Department of Energy

**Program Plan for Analysis of Shear Wave Velocity Data to Address Uncertainties in
Estimates of Hanford Ground Motion Waste Treatment Project**

August 27, 2004

Figure 1. Location of Geologic Profile (on next page) from the IDF site through the WTP site.

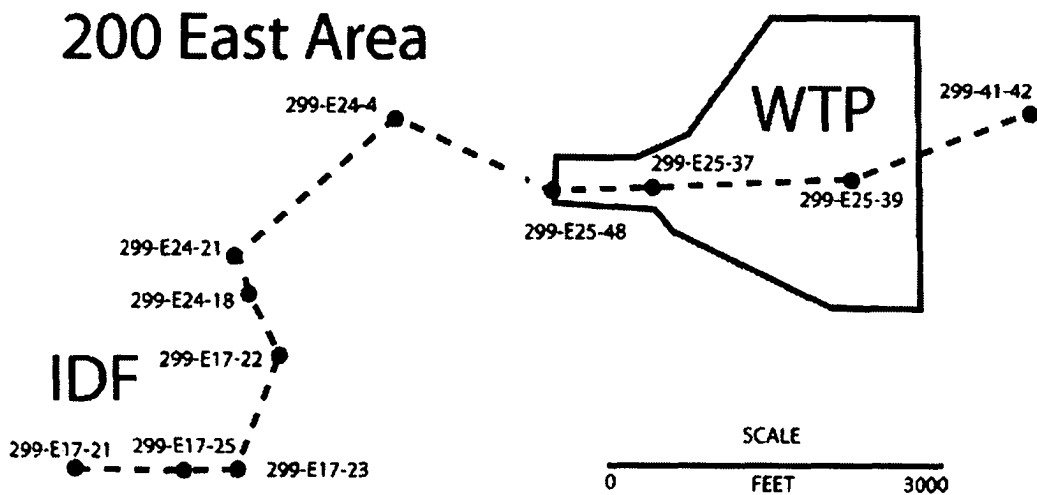
Issue #1: *Comparison of the geology and the intervening paleo-channel between the Integrated Disposal Facility (IDF) site and the WTP site; the overall thickness of soil (depth to bedrock); the thickness of individual soil layers (Hanford and Ringold formations); Vs for all layers (soil, basalt bedrock, sedimentary interbeds); and potential lateral variation in Vs.*

The detailed supra-basalt (sediment above the basalt) geology in the area surrounding and within the WTP site will be assembled and presented, using data from numerous boreholes that have been drilled and logged as part of the IDF site (adjacent to WTP) and other previous studies in the nearby area (see Figure 1). These data provide the thickness of each individual soil layer in the Hanford and Ringold formations, and depth to basalt bedrock, at numerous geographic locations surrounding and within the WTP site. Lateral variations in some of the lower sedimentary layers (Ringold formation), such as the paleo-channel that lies between the IDF site and the WTP site are known, but the sedimentary structures outside of this erosional channel are the same as those at the IDF and WTP sites, and addition to other nearby locations outside of this erosional channel. The paleo-channel does not affect the structure within the basalt sequence (see Figure 2).
